MORGAN OFFSHORE WIND PROJECT: GENERATION ASSETS

The Applicant's response to Interested Party submissions made at Deadline 5

Document Number: MRCNS-J3303-RPS-10239

27 February 2025

Figure 13.1: Vessel traffic between the Morgan Generation Assets, Moir Vannin and Walney wind farms.

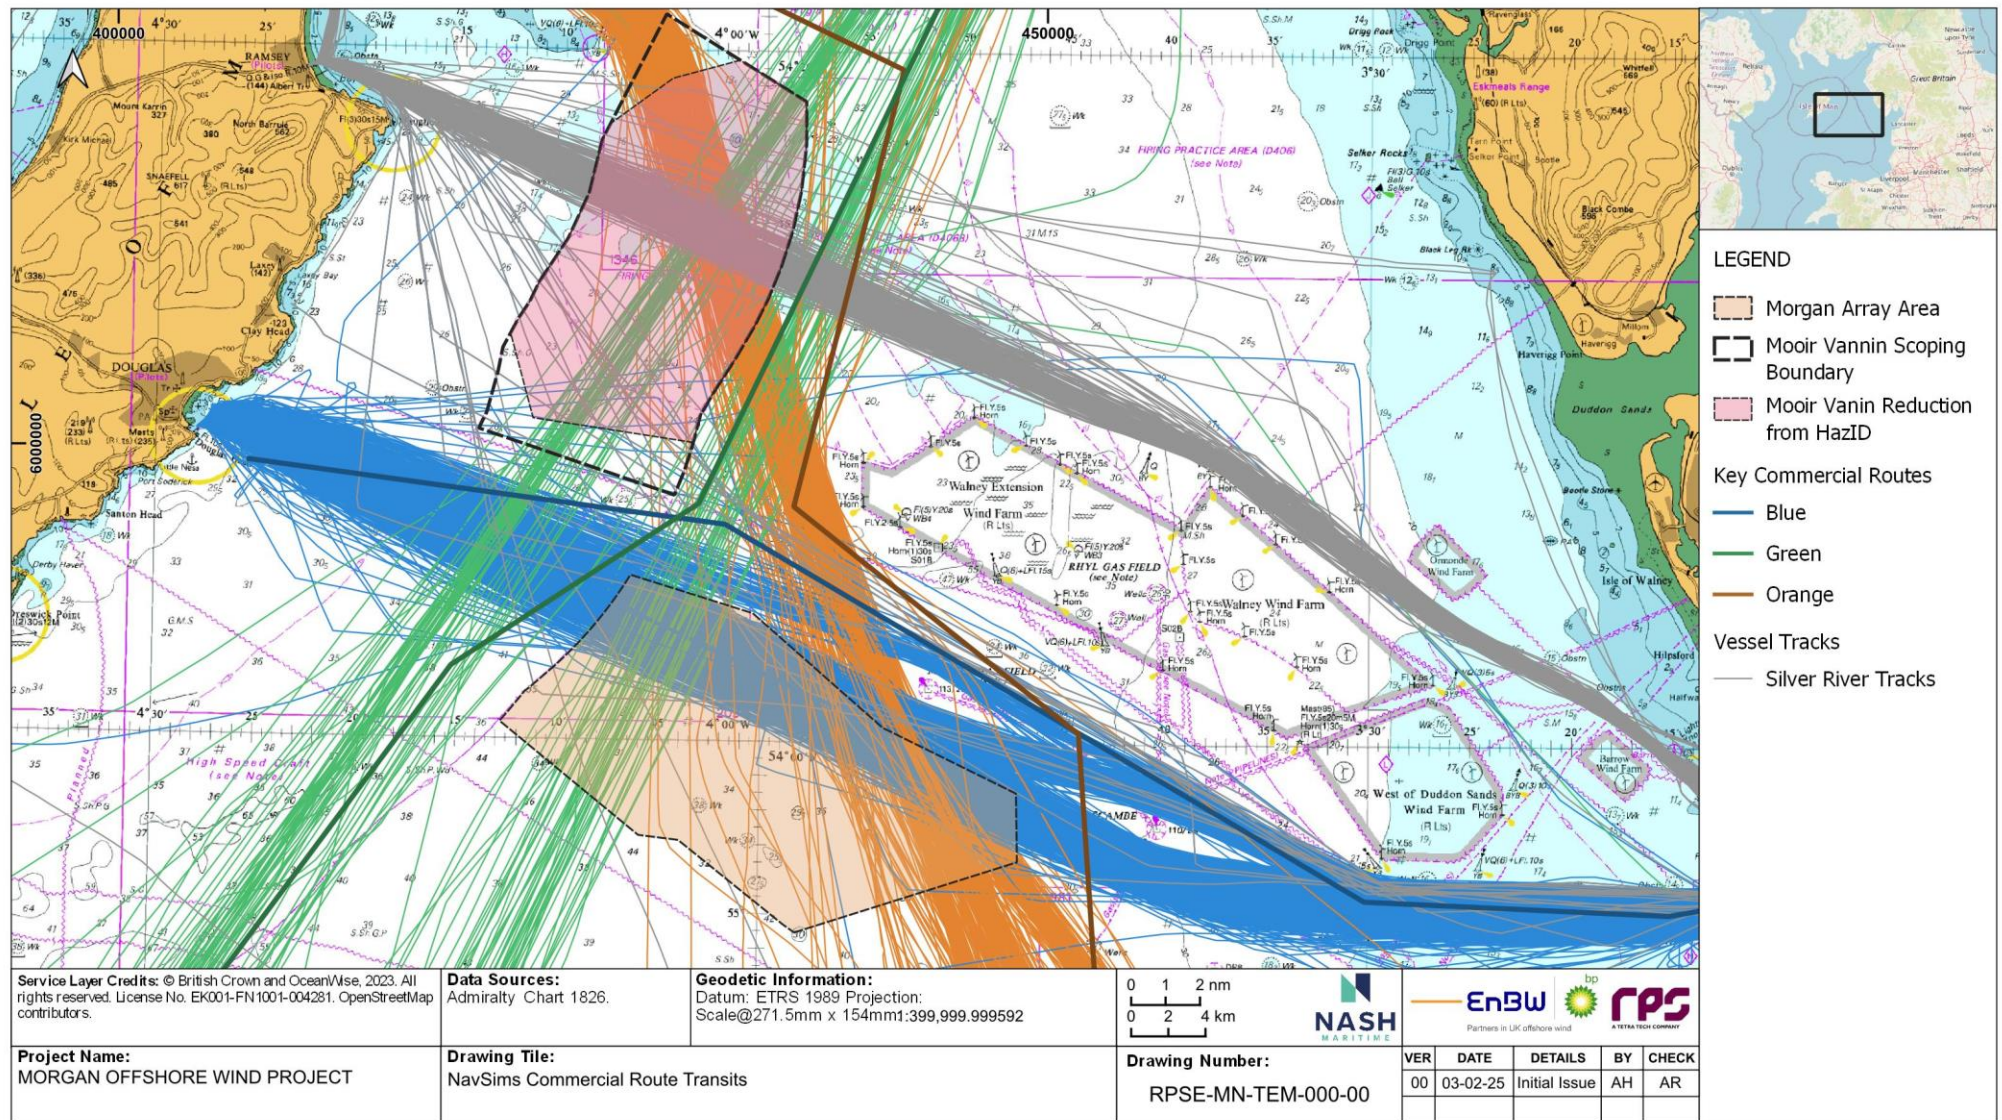
- 13.1.1.16 Noting MVOWFL's response to ExQ2 question SN 2.4 (precedent for restricted navigation corridors), whilst the Applicant agrees that precedent alone does not demonstrate a proposed passage is safe, it does provide useful benchmarking. Precedent demonstrates that narrower passages with significantly greater traffic densities have been assessed to be safe.

- 13.1.1.17 The Applicant agrees that following the refinements made by MVOWFL, the gap between the Morgan Array Area and Mooir Vannin Array Area does not constitute a corridor and this is also supported by the MCA's response to ExQ2 (REP5-069).

13.1.1.11 The Applicant's Safety Justification of the revised 4.1 nm gap between the Mooir Vannin Array Area and Morgan Array Area (S_D6_42) shows that the array boundary refinement made by MVOWFL is consistent with guidance and precedent, and has reduced the risks to Tolerable and ALARP. Figure 13.1 shows the four main routes of commercial traffic impacted by either the Morgan Generation Assets or Mooir Vannin Offshore Wind Farm, with the refined gap addressing the passages of IoMSPC between Heysham and Douglas (highlighted in blue) with passages to the east or north of Mooir Vannin (highlighted in orange and grey) to be addressed by MVOWFL.

13.1.1.12 As discussed during Issue Specific Hearing 3, both MVOWFL and the Applicant agree that the 4.1nm separation distance between the proposed Morgan Array Area and proposed Mooir Vannin Array Area meet, and exceed, all relevant guidance, which the MCA also confirmed they are content with. Additionally, the refined separation distance exceeds the accepted separation of both constructed and consented passages elsewhere in the UK, as set out within the Applicant's response to ISH 2 Action Point 2 (REP4-005).

Figure 19.1: Areas of queen scallop dredging and existing infrastructure within the Irish Sea

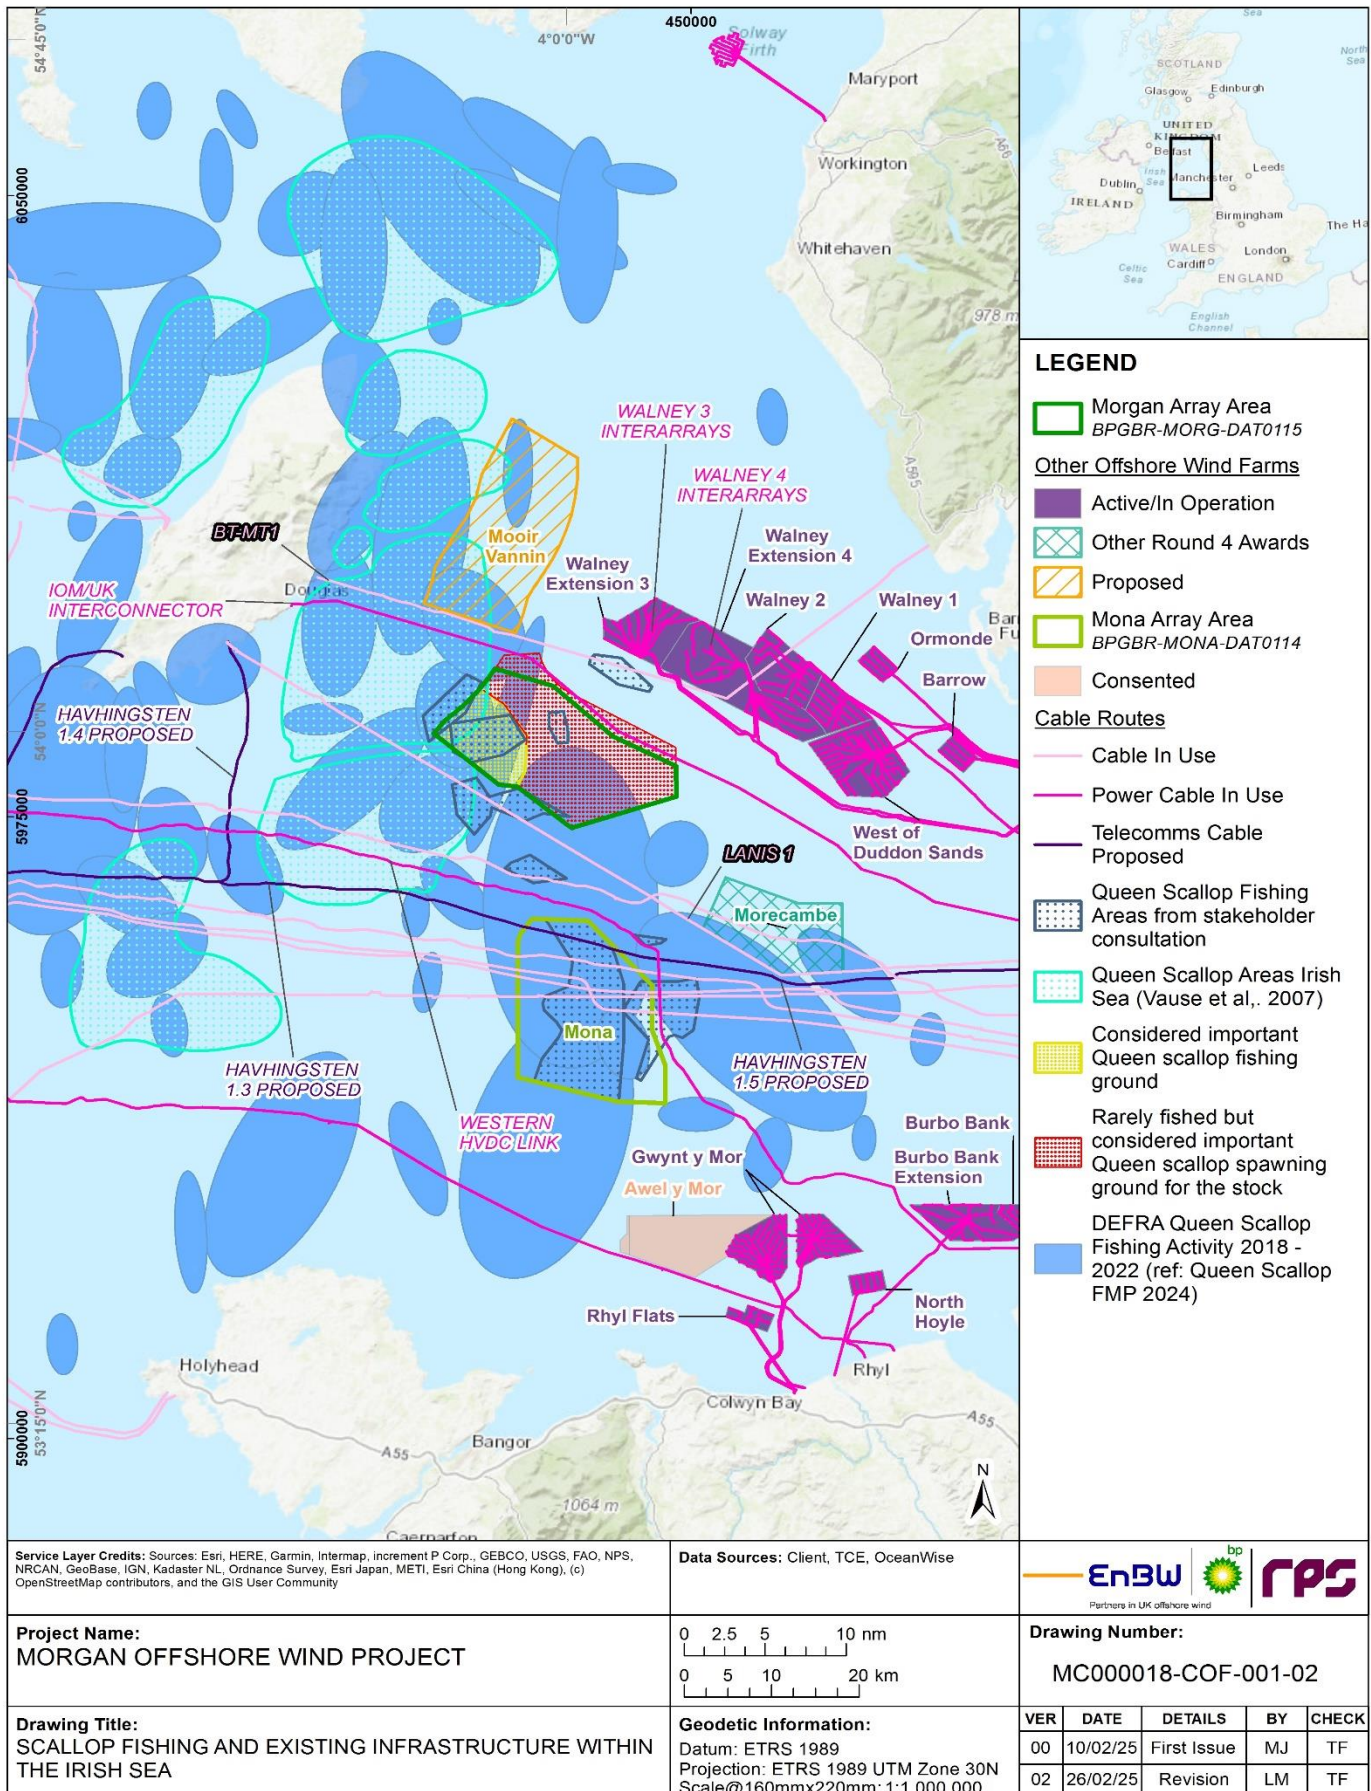
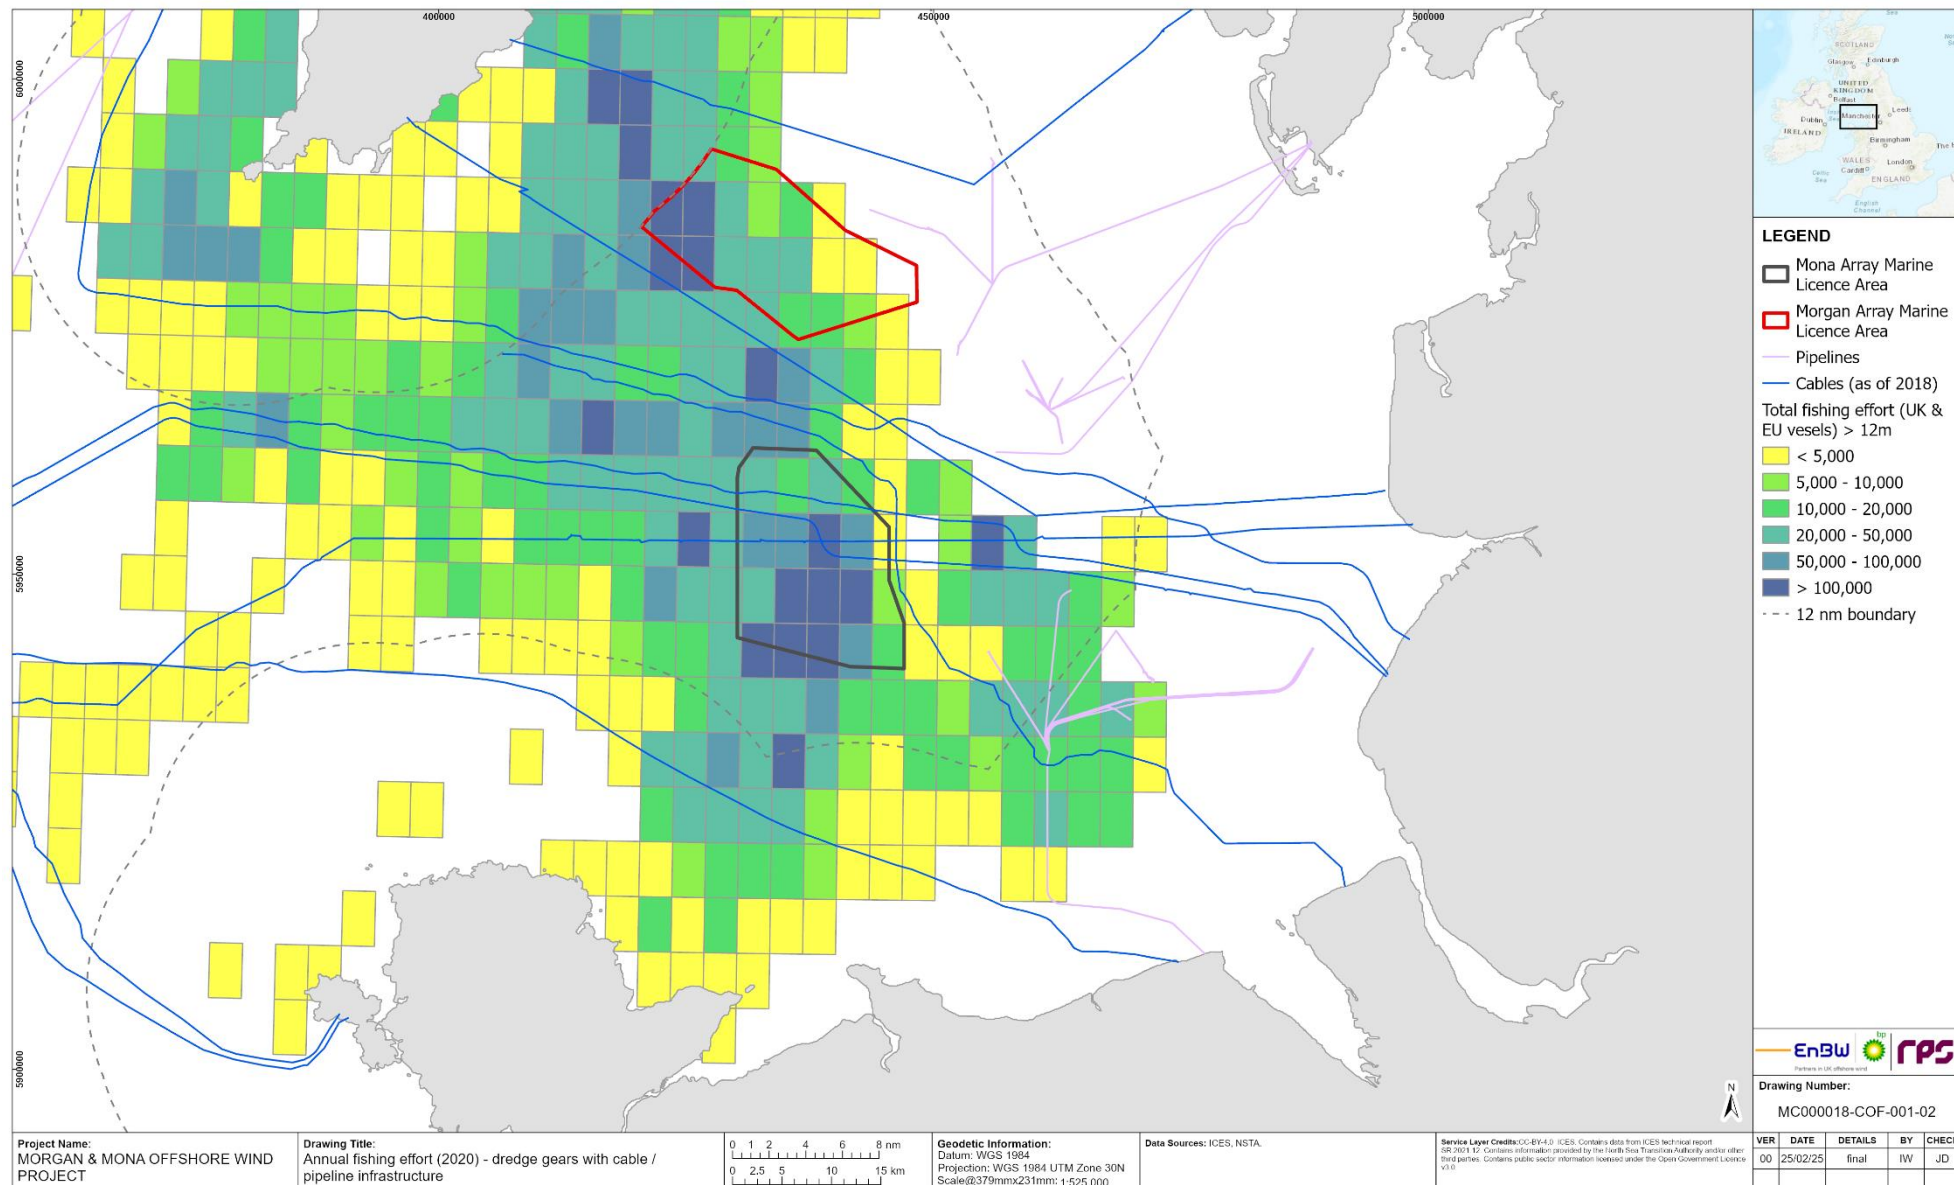
- 19.1.2.8 During Issue Specific Hearing 3 (ISH 3), WCSP acknowledged that scallop dredge vessels already operate in areas with buried cables and associated protection, adjusting their activity accordingly. This is further evidenced in Figure 19.1 and Figure 19.2, which illustrates existing infrastructure and fishing grounds within the Irish Sea, showing that queen scallop dredging actively occurs in areas where subsea cables are present. Within the proposed Mona Array Area, for example, four cables traverse key scallop fishing grounds, as identified through stakeholder consultation. These cables are spaced at varying distances, with the closest being 0.49 km between the Rockabill and Sirius South cables (Table 19.1). Additionally, the Western HVDC Link and Hibernia Atlantic Seg A cross queen scallop fishing grounds southwest of Morgan, with a separation of 1.98 km. Despite the presence of these cables, scallop dredging continues in these areas, demonstrating that fishing activity can successfully coexist with subsea infrastructure.
